ADDENDUM TO REQUEST FOR PROPOSAL  
FOR  
Val Marie and West Val Marie Dams  
Service Contract No. 5  
Geotechnical Reviews  
REQUEST FOR PROPOSAL # 4547:928-7V1-0-S1-5

Addendum No. 1

<b>Val Marie Dam</b>			<b>C118</b>
	Drawn/Checked: EH/WR	2007/11/29	4547:928:7V7	1 of 1

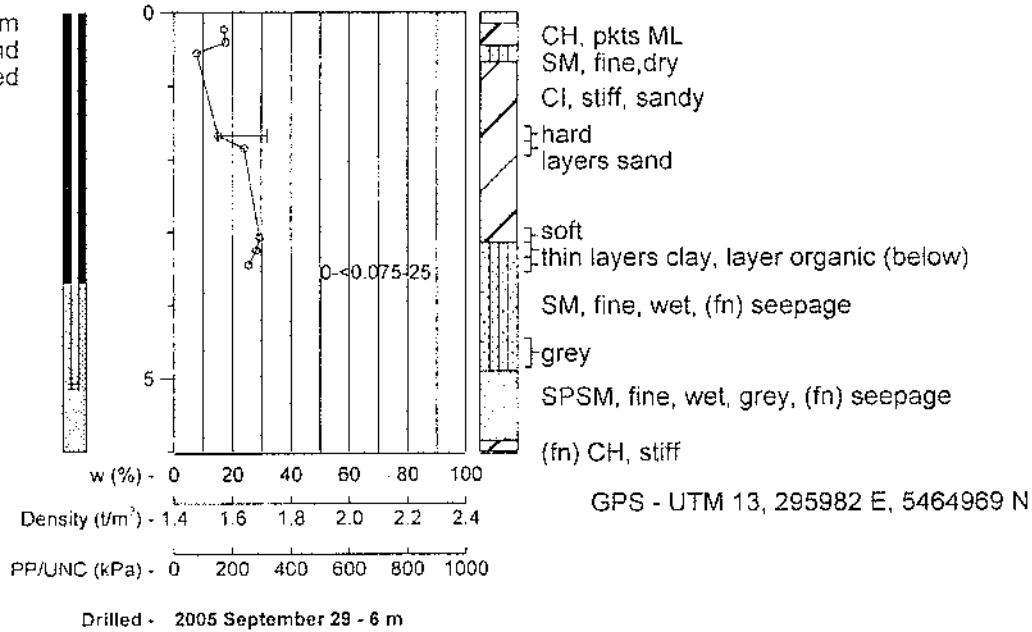
Q1 - In the supplemental information that was provided to the proponents for the Val Marie Dam the attached test hole logs (C117, C119, C120) are not shown on the corresponding map and conversely the test holes shown on the map (C113, C114 C115 and C116) where not included in the supplemental information. Would be possible to get the test hole logs for C113, C114 C115 and C116.

A1 - The test hole logs C117, C119 and C120 are not on the map as it appears the map was created before these were drilled – and not updated.

Piezometer C113 is actually shown on plan 356904 with borehole C117, piezometer C114 on plan 356905 with borehole C121, piezometer C115 on plan 356906 with borehole C119, and piezometer C116 on plan 356905 with borehole C120. These plans were included in the supplementary information, however plan 356905 for Piezometer C114 was not included because it has been was decommissioned - is now attached.
